**Re: DPIE Submissions for proposed Modification 2 of the Dunmore lakes Sand
Project – Email from Boral 14/08/2019**

DPIE and Shellharbour Council have provided submissions regarding the proposed Modification 2 of the Dunmore Lakes Sand Project. This submissions relate to water quality and flooding issues addressed in the Surface Water Assessment prepared by Southeast Engineering and Environmental. (Table 1).

Table 1 Summary of submission issues and response.

FIG 41. 5y ARI Flood extents pre and post.
18/07/2019

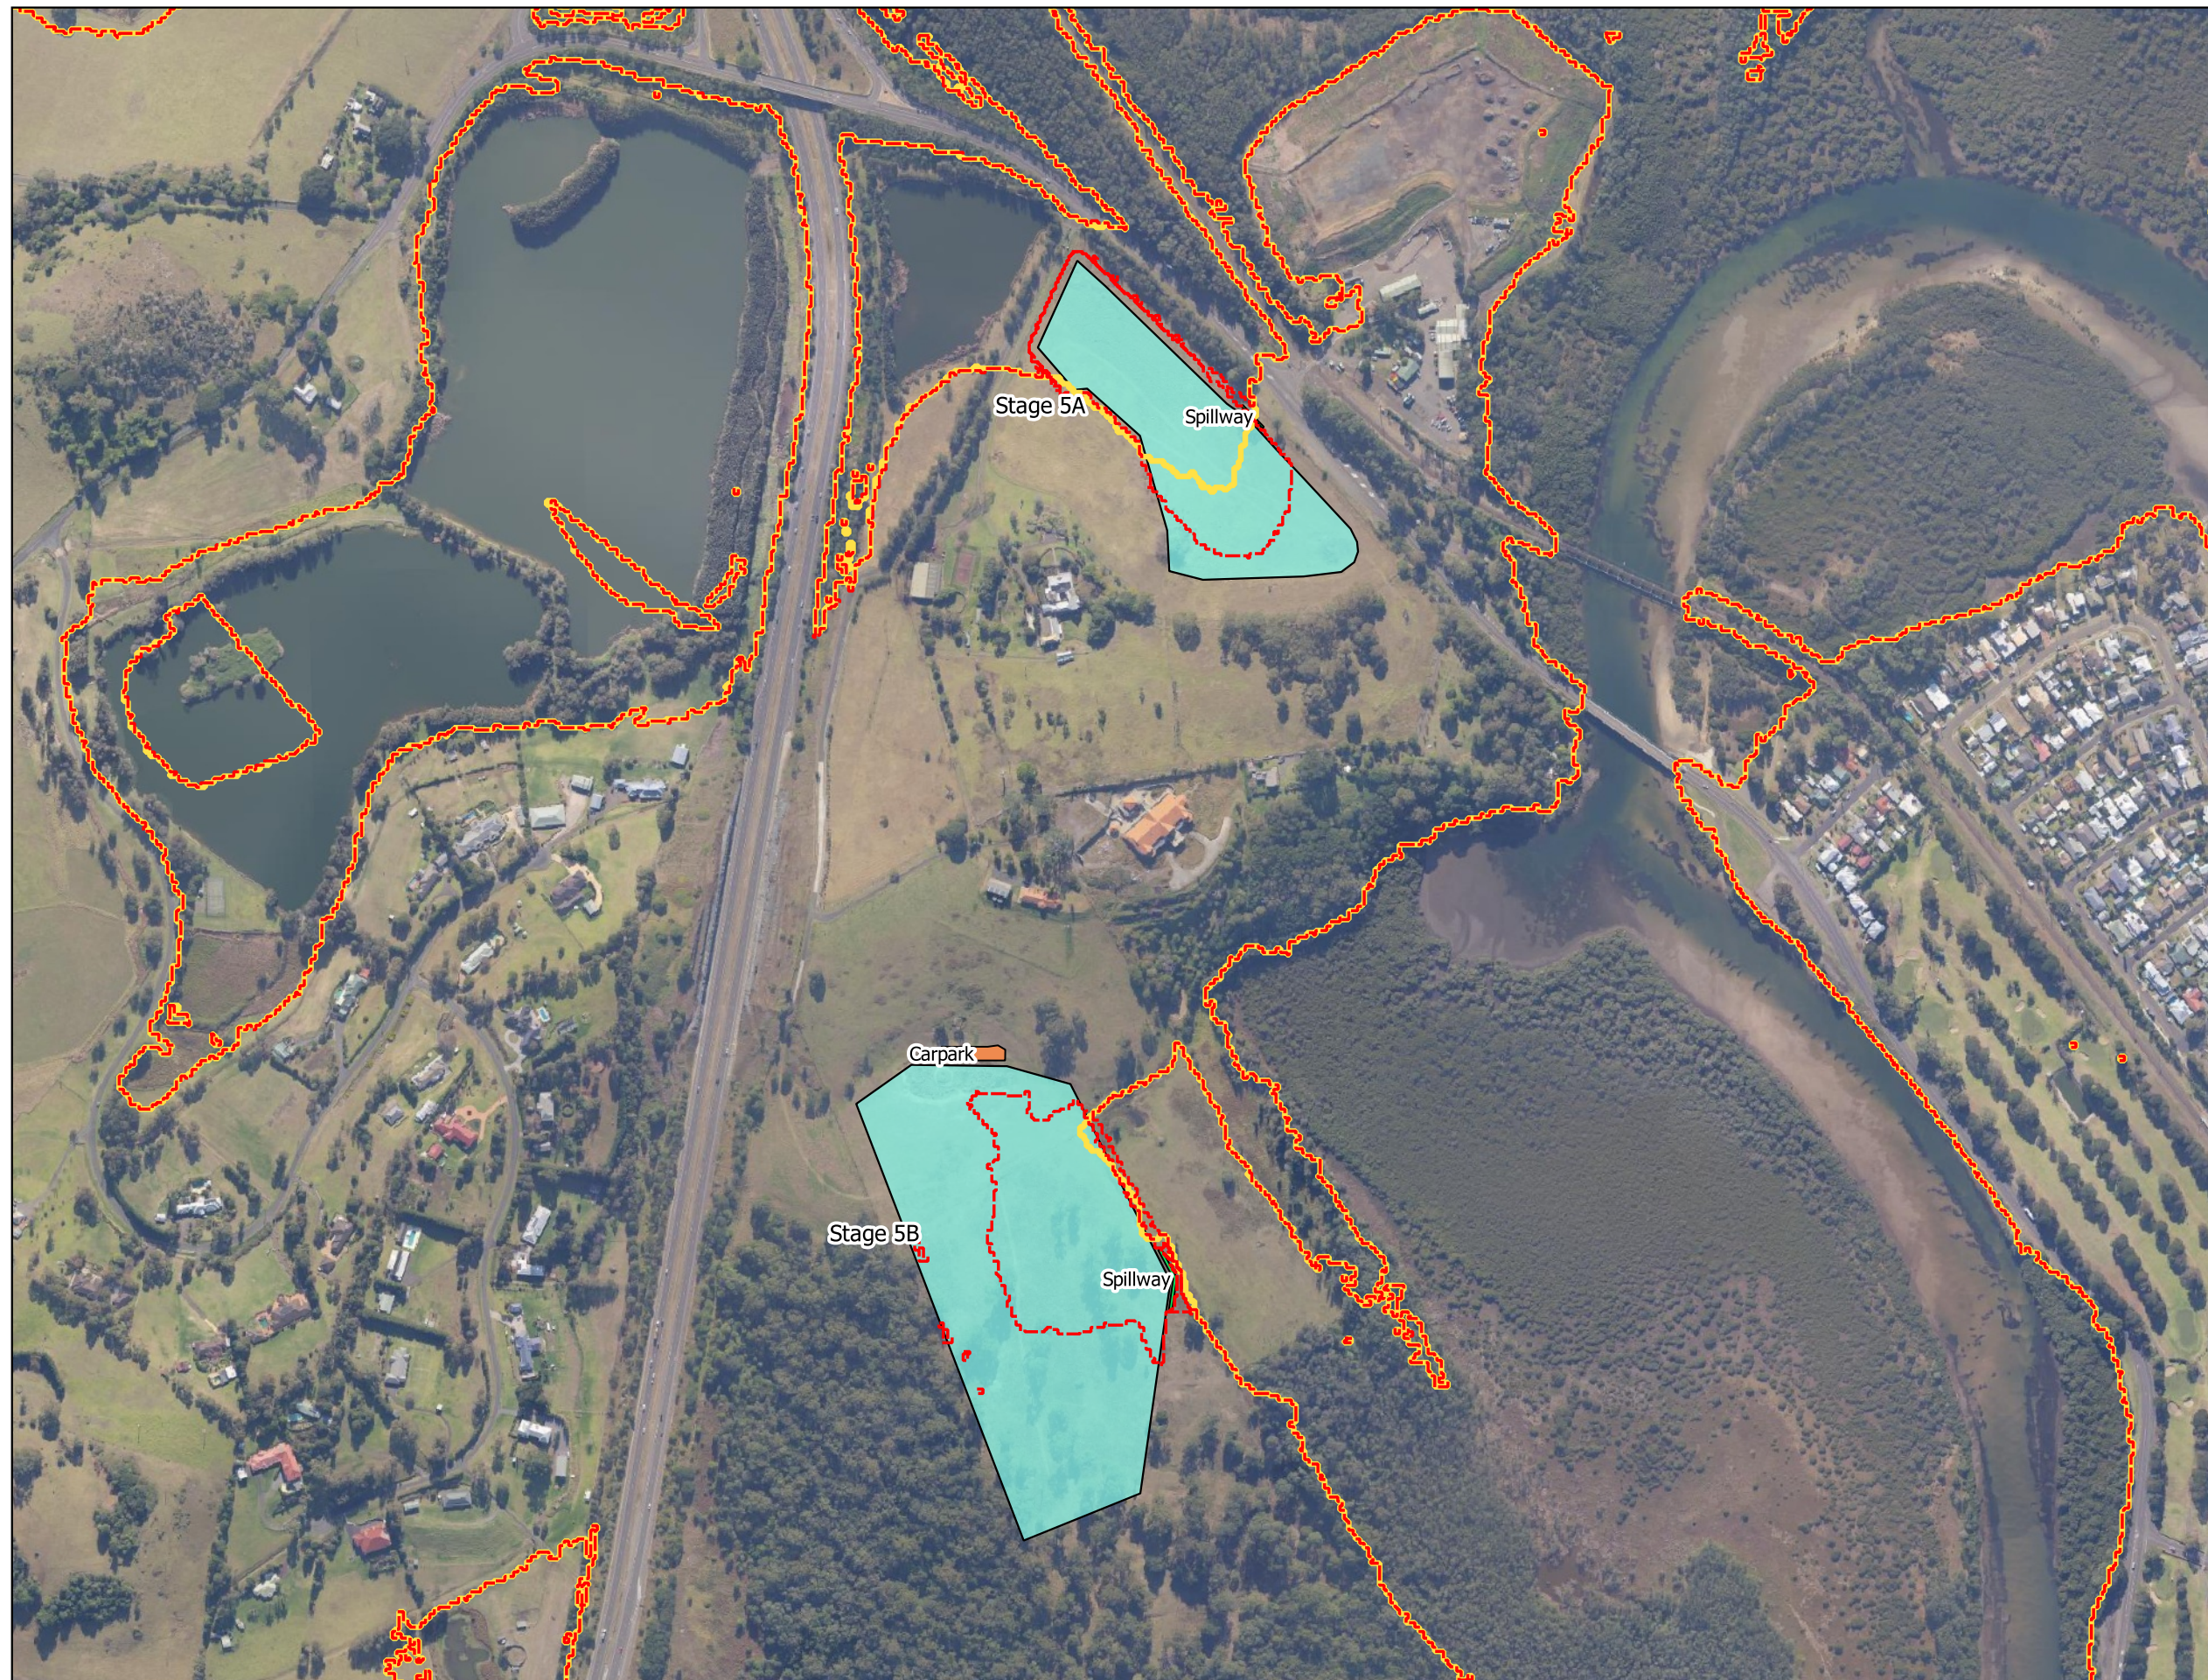
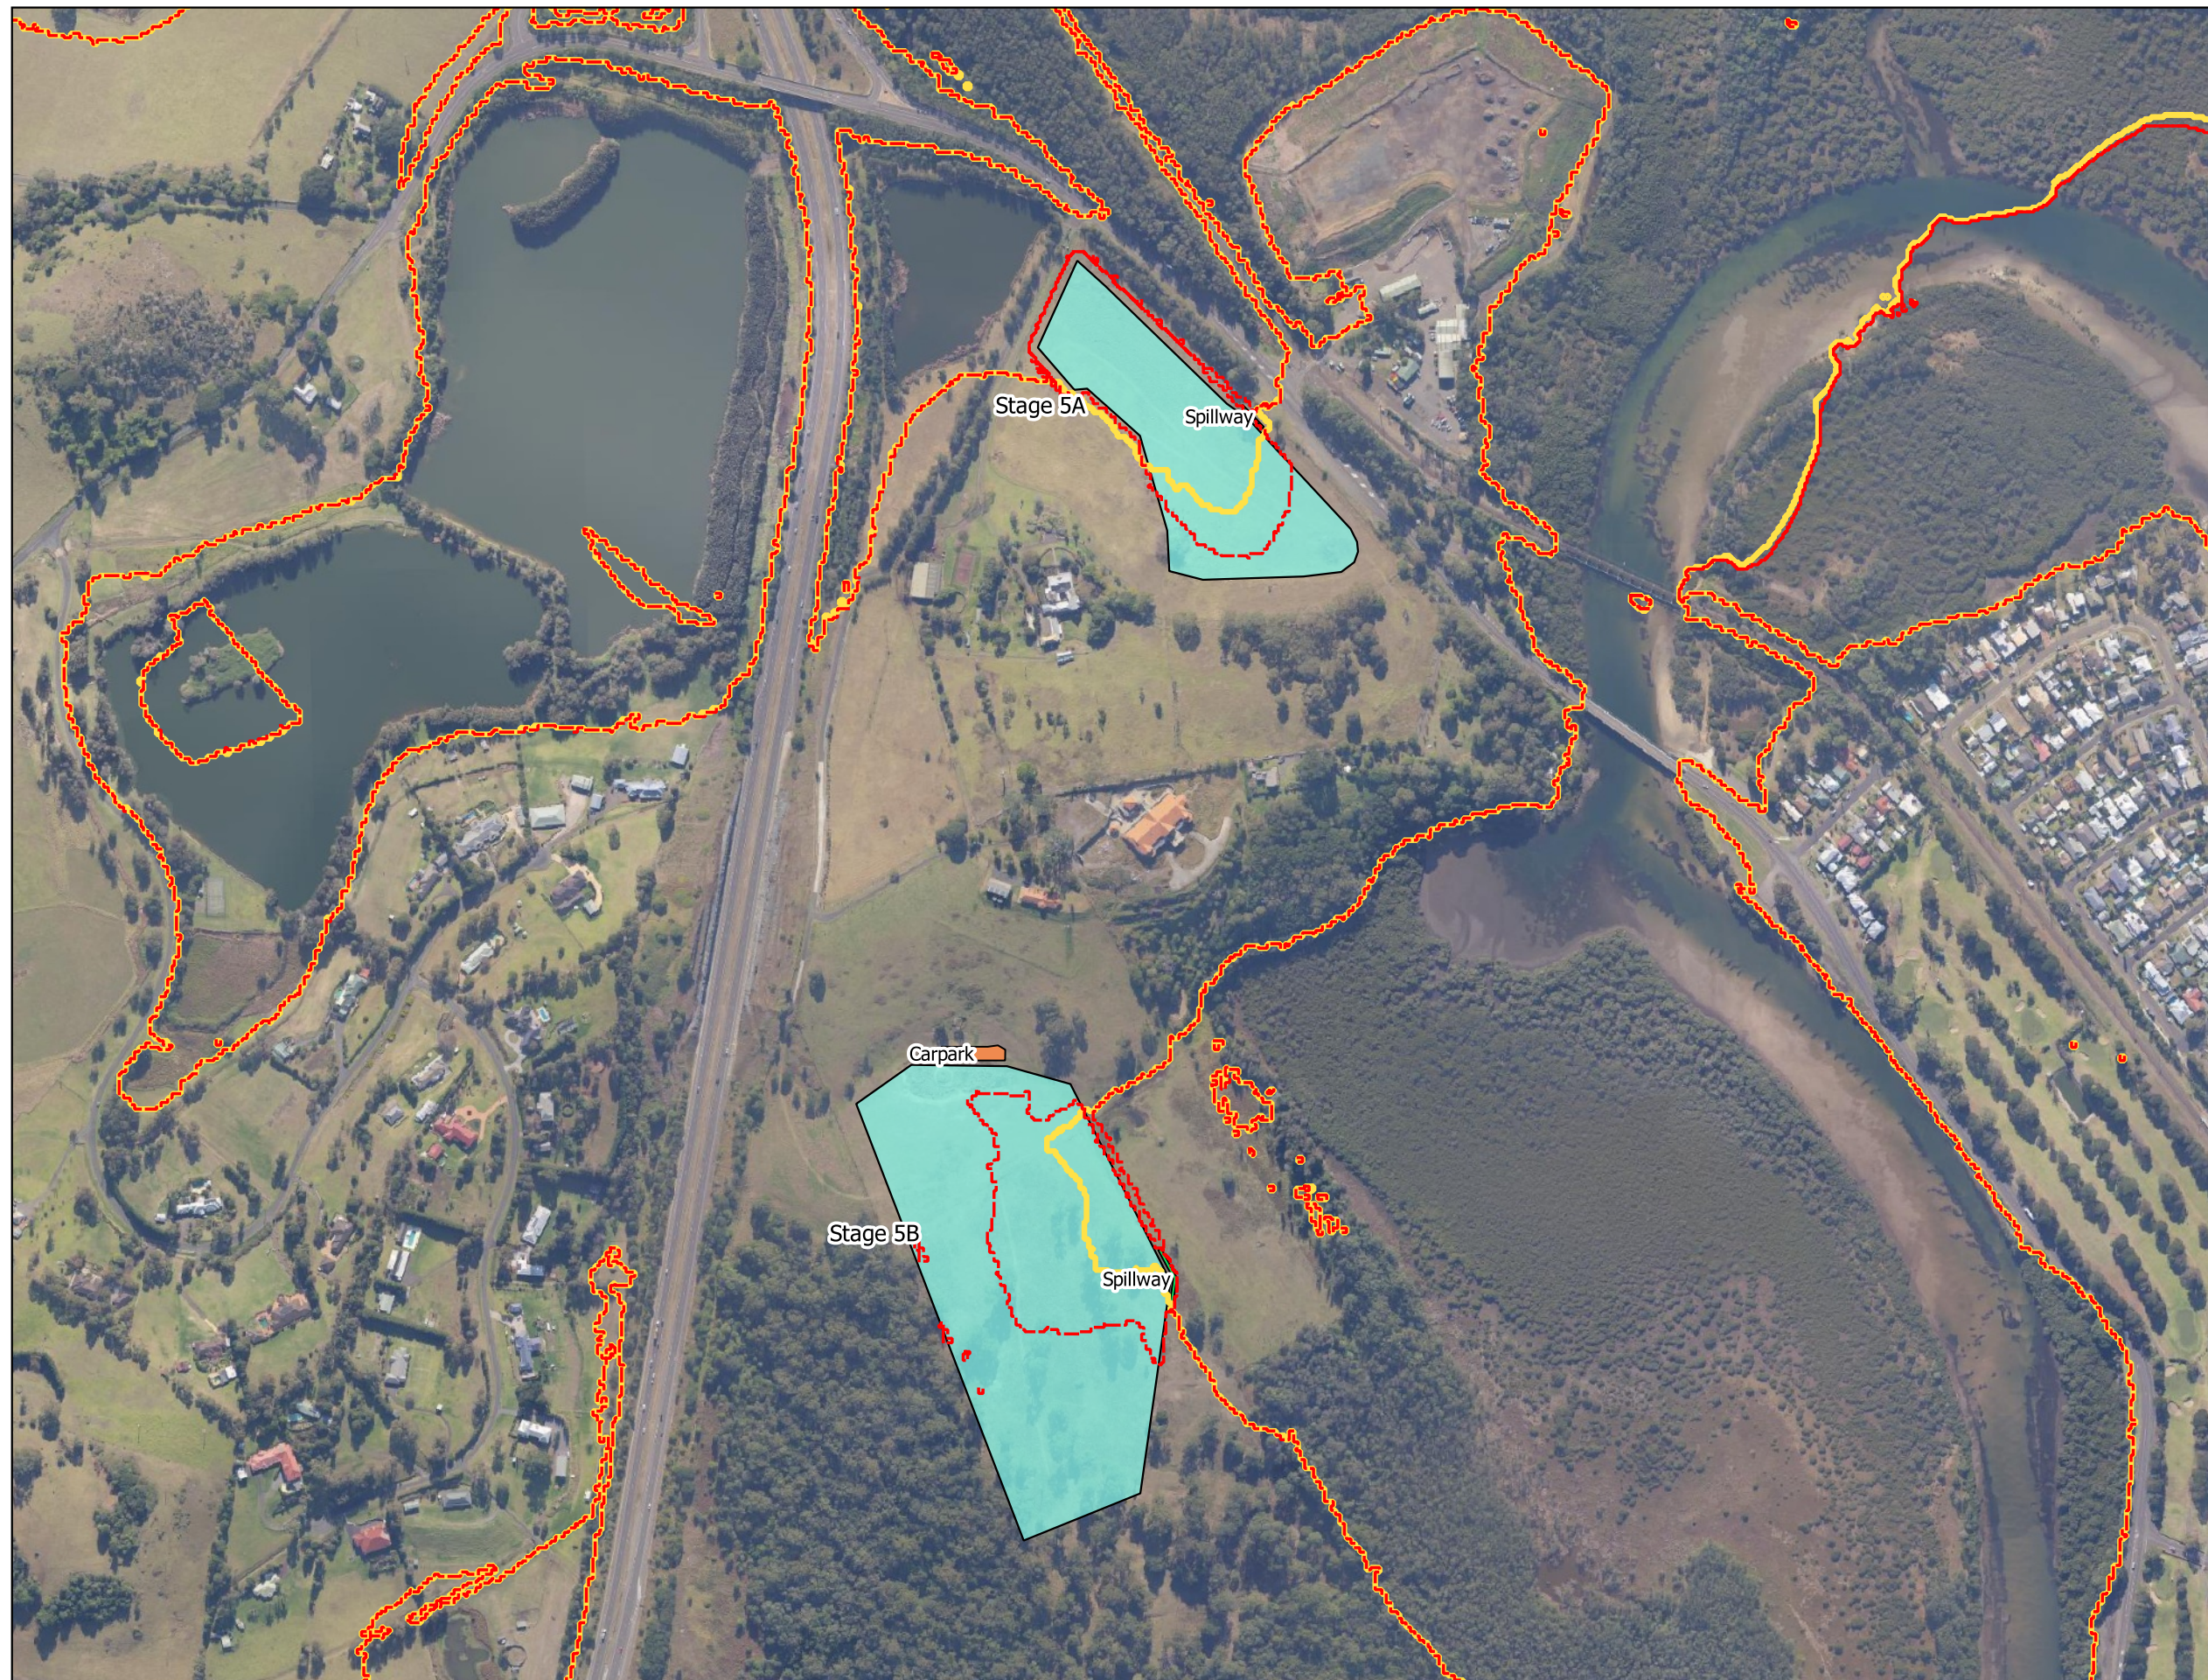
<i>Identification of any new areas that would be subject to flooding;</i>	<p>Refer to flood mapping provided in Appendix A. These include Figures 41 – 44 which show the extent of flooding for the 5, 20, 100 ARI and PMF events. The largest changes are within the proposed basins, this is due to the starting conditions of the model runs which start with the ponds overflowing slightly.</p> <p>Beyond the basins the largest change in extents is associated with the 5year ARI event, refer to figure 37 which shows the largest change in depth to the west of Stage 5A of between 40-50mm. Figure 41 shows the associated slight change in extents.</p> <p>For the large events changes to flood extents are confined to the pond areas and are due to the aforementioned model starting conditions.</p>
	<i>Discussion of the impact of any introduced hardstand areas</i>	The hardstand (carpark) area proposed to the north of the Stage 5B dredge pond is located above the PMF flood level at approximately 5.5m AHD. The PMF peak flood level is 5.2m AHD. The introduced hardstand area has no impact on flooding.
